# A12 Chelmsford to A120 widening scheme

TR010060

## 9.24 Applicant's Comments on Written Representations

**Applicant's Comments on Written Representations**

**Plate 1: Extent of modelled fluvial flood extents in the context of the Order Limits and proposed alternative mitigation area**

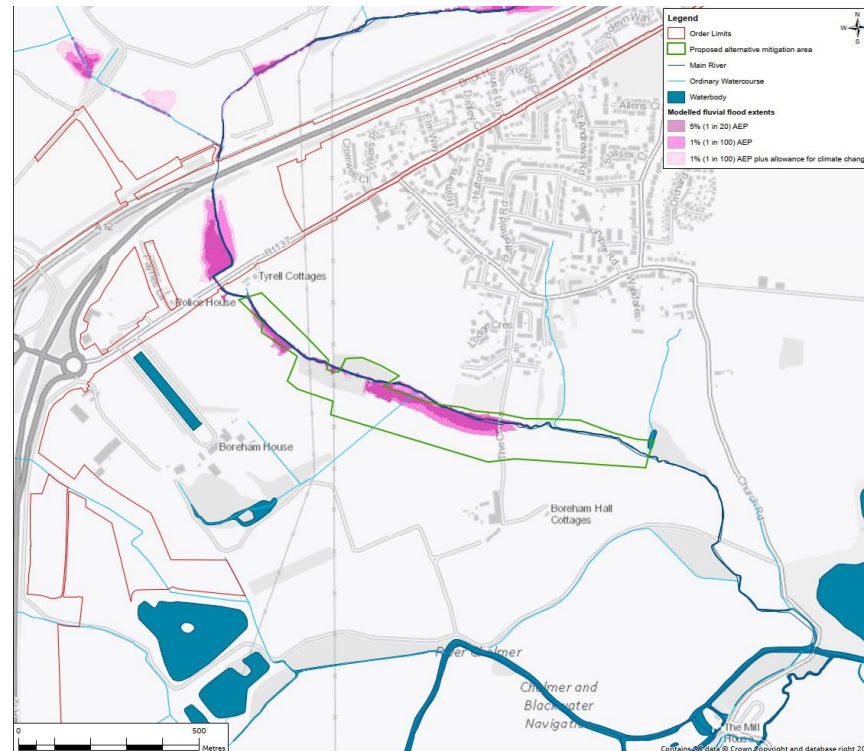
Parties against the design principles outlined in the response for REP2-051-004, as it is recognised this would be more agreeable to the Interested Party.

However, unfortunately a significant proportion of the proposed alternative location is within the modelled fluvial flood extents of the Boreham Brook, as shown by the Applicant's fluvial flood model shown on Sheet 2 of 11 of Figure 14.4 of the Environmental Statement [APP-242] and also in Plate 1 below. Detailed hydraulic modelling of Boreham Brook has informed the design at this location as it is considered to be more accurate than the published flood zone mapping. It is noted that the Environment Agency has accepted the hydraulic modelling undertaken to inform the Flood Risk Assessment (paragraph 2.1 of their Relevant Representation (RR-011) dated 4/11/22). For this reason alone, the proposed location does not therefore satisfy the criteria as outlined in the general design principles (as advised by Natural England's Standing Advice) to constitute a suitable reptile receptor site.

In addition, the location of the proposed alternative location does not coincide with the ditches in which water voles have been most recently recorded. It is therefore considered that siting the mitigation as shown in the proposed alternative location may prevent the Applicant mitigating construction effects on water vole if required to enable construction of the attenuation ponds within Plot 1/11a or in the absence of this requirement, it would prevent delivery of enhancements with respect to water vole, in compliance with
